NUCLEAR REGULATORY COMMISSION

Title: Advisory Committee on Reactor Safeguards

ABWR Subcommittee: Open Session

Date: Friday, November 22, 2013

Figure 10.2-5 Turbine Overspeed Trip System Functional Diagram

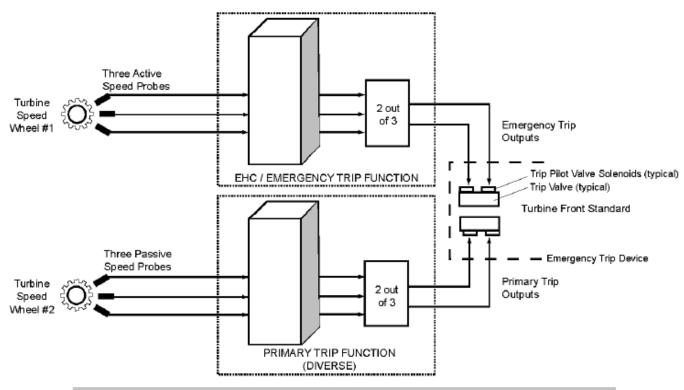
And the three active sensors, both of those, that is okay depending on what they do when they get inside the box called "emergency trip monitor box." You provided another figure in one of your presentations which was cancelled, the overall meeting was cancelled, which showed the three sensors come in to the overspeed trip function, and each sensor feed -- all three trip monitors, all three speed monitors are fed by all three sensors.

The bottom part of that upper section there's three things called speed monitors. All three of those sensors feed all three of the speed monitors. So they are all tied together. Those three speed sensors also feed the normal mode of operation. How they are tied together -- I think they are tied together in the upper one. I never got a figure of that, but based on the text that I was able to read in a few places, it looks like it's done by both -- there's a backup and -- there's a normal and a backup channel, and all three feed all in -- you pick the median. MR. THOMAS: You have -- a signal from each sensor goes into its processor. MEMBER BROWN: That's right.

it MEMBER **BROWN:** However happens, it's -- that's not show anywhere. It just shows a line coming off the sensors going into the other boxes. detail is not clear as to how they're hooked up in the normal function.

So if you have what I would call not a failure of a sensor or a processor per se, but an anomalous noise, some other interaction from the sensor getting fed into those three speed monitors, they can be told, "I didn't see a trip." I'm not calling it a software failure; it's just that you can provide a signal, a noise. I've seen it happen, and that's the other genesis of the concern I have.

Show that other trip functions preclude any common mode failure (e.g., generating a false input of "zero turbine rpm") of normal turbine speed control and emergency overspeed trip functions, while the primary overspeed trip function is taken offline (passive sensors, no automatic trip).

So operation for a "limited period of time" with the primary trip system out of service is 3 acceptable. And this term "limited" is not defined, and I think that is the question. What is reasonable? What 5 is appropriate? If we go to the next slide --6 7 CHAIRMAN CORRADINI: So before you go to 8 the next slide, are you two on the same page? 9 MEMBER BROWN: Roughly. I have a little 10 bit of disagreement on the power load on balance. 11 CHAIRMAN CORRADINI: But at least for what 12 he brought up, you're on the same page? 13 MEMBER BROWN: Yeah. 14 CHAIRMAN CORRADINI: Okay. 15 MEMBER BROWN: For the most part. 16 if you look at it from the standpoint of standard part 17 failures, then, yes. If you look for what I would call unusual anomalies that may occur, then not necessarily 18 19 until I heard the end. 20 MR. THOMAS: I didn't want to get into the 21 discussion about, you know, we are still connected to the 22 grid and that. I think the power --23 MEMBER BROWN: There are different things 24 that happen if you are on the grid or off the grid. 25 MR. THOMAS: other There are some

Now, I think, finally, that we do, again, periodically take these things out of service. The terms "limited" and "continued operation" are not explicitly defined. And in talking through this, really, with myself and Scott and some others that are familiar with these type of circumstances, I think my advice to the plant manager under these circumstances is that you can't operate like this for six months. You can't operate like this for a month.

- As described in the FSAR, many of the components of the various turbine control systems are routinely taken out of service for a "limited" period of time for testing.
- This is acceptable because other redundant functions are available to provide adequate protection.
